Subject: RE: 088210-37 (2RP-3226) Perdomo BMP Sate #1H Assessment Summary Report ~COR-088210-37~

RE: EOG \* Perdomo BMP St 1H \* 2RP-3226 \* DOR: 8/19/15

**EOG RESOURCES** EDDY COUNTY, NEW MEXICO PERDOMO BMP STATE COM No.1 DETAIL OF AREA "A"

SAMPLE LOCATION MAP

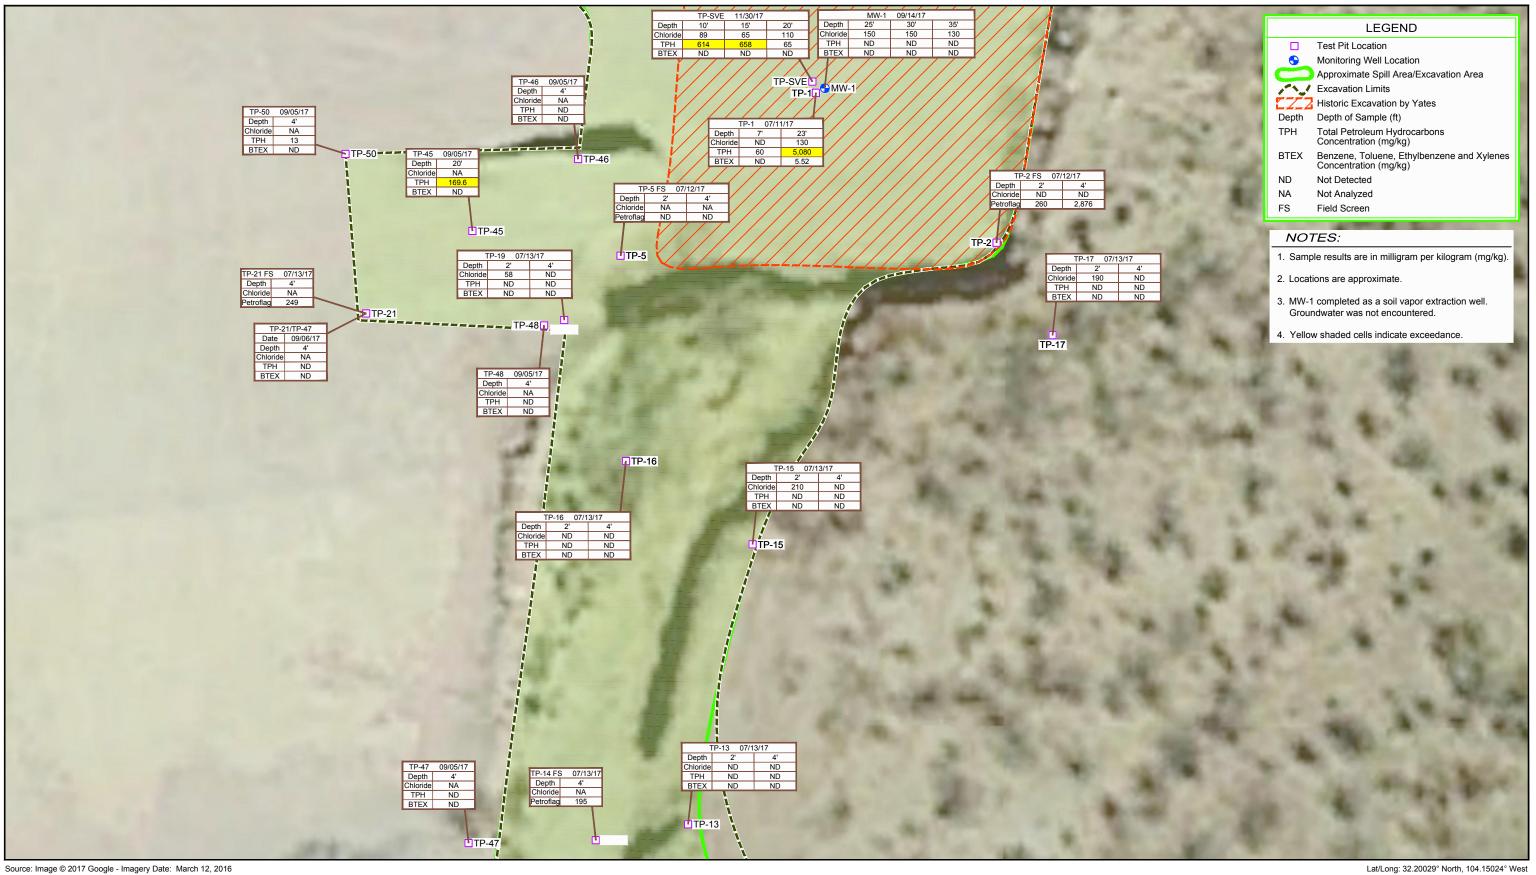
Please see the attached figure, we collected additional sample data as you requested. Soil samples were collected at depths of 10, 15, and 20 feet below ground surface in TP-SVE near the MW-1 location. The sample collected from 20 feet contained a TPH concentration of 65 milligrams per kilogram. We are scheduling the remedial activities to include the plugging and abandonment of the SVE well and excavating/placing a liner to 4 feet below ground surface in the area of the SVE well. We will notify you once we have the dates scheduled.

- The proposal for deferral of the area around the pipeline riser is approved. Notations will be made on the Final C-141 and in OCD database, which will reflect in OCD Online files.
- The request to backfill a portion of the site (the southern edge) is approved.
- As discussed, additional sample data will be obtained in a manner that will allow for further evaluation the upper portion of the area identified as SP-1/MW-1

Per our phone conversation earlier, you are approved to continue the project as scheduled.
